## Accessibility Audit

**Airedale Junior School**  
Fryston Road  
Airedale  
Castleford  
WF10 3EP

Date 08/10/2015

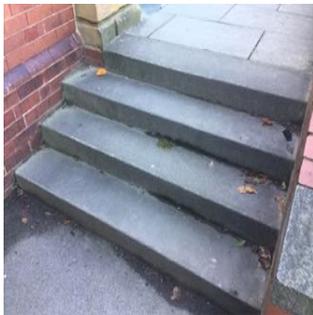
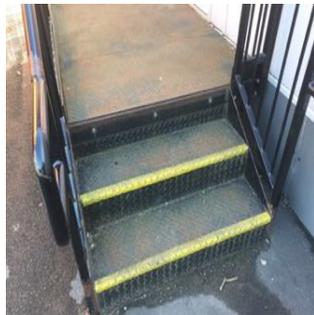
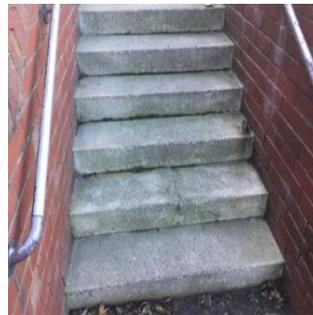
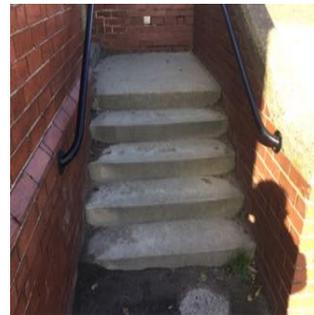
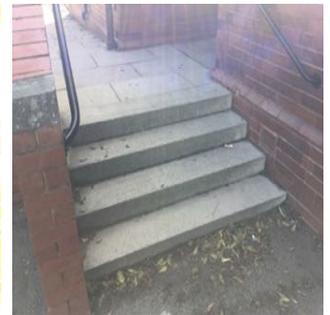
4.6 - Nosings readily identifiable? If nosings are painted, is the paint still durable with no wear and tear?	B	The external steps do not have suitable colour contrast provided to the edge of the step nosings. The steps up to the mobile building require repainting. The left side fire exit steps from the mobile building does not have the top step highlighted.

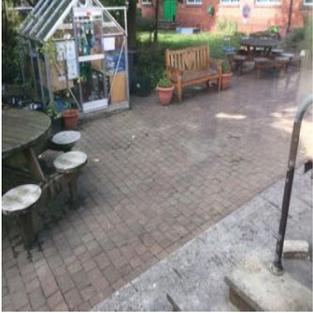
Question	Response	Details
5.10 - Weather mat of firm texture and flush with floor?	D	At the next refurbishment for the site, consider installing recessed mats rather than the current loose ones to minimise the potential tripping hazard. At another site we've surveyed, similar mats to these were provided and someone tripped up on one of the loose corners.
 <p data-bbox="264 724 353 746">Photo 36</p>		
5.11 - Are automatic doors provided? If so, do these remain open long enough for a slow-moving person to pass through? Are visual and tactile warnings provided?	B	Automated door openers would be beneficial for the main entrance when budget permits. Potentially coincide with recommended works for the main entrance. This would increase accessibility for a range of users.

5.10	At the next refurbishment for the site, consider installing recessed mats rather than the current loose ones to minimise the potential tripping hazard. At another site we've surveyed, similar mats to these were provided and someone tripped up on one of the loose corners.	At the next planned refurbishment for the site, consider installing recessed mats which are flush with the surrounding flooring.  Refer to BS8300 - any matting should either have its surface level with the adjacent floor finish or, if surface laid, be of a type that has a rubber backing and chamfered edges. if, in exceptional circumstances other types of surface laid mats are used, they should be securely fixed to the floor at their edges and at any joints, to avoid the risk of tripping or slipping.	<b>M</b>

Photo 59

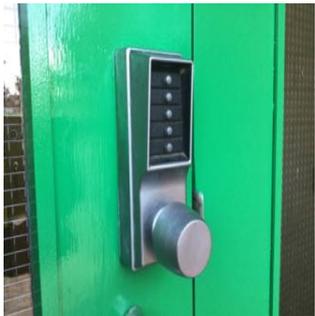
8.7 - Where there are security keypads or readers, are these suitably positioned for potential staff members with disabilities?	D	There is a mixture of keypads used on site and are positioned too high off the ground floor level for wheelchair users. Many people with dexterity impairments can find these difficult to use.

8.7	<p>There is a mixture of keypads used on site and are positioned too high off the ground floor level for wheelchair users. Many people with dexterity impairments can find these difficult to use.</p>	<p>A review should be undertaken to assess whether it would be possible to remove these keypads and switch over a swipe card system.</p> <p>According to BS8300 - Disabled people with a weak hand grip or poor co-ordination, find that using a card to open a door lock is easier.</p>	<b>M</b>
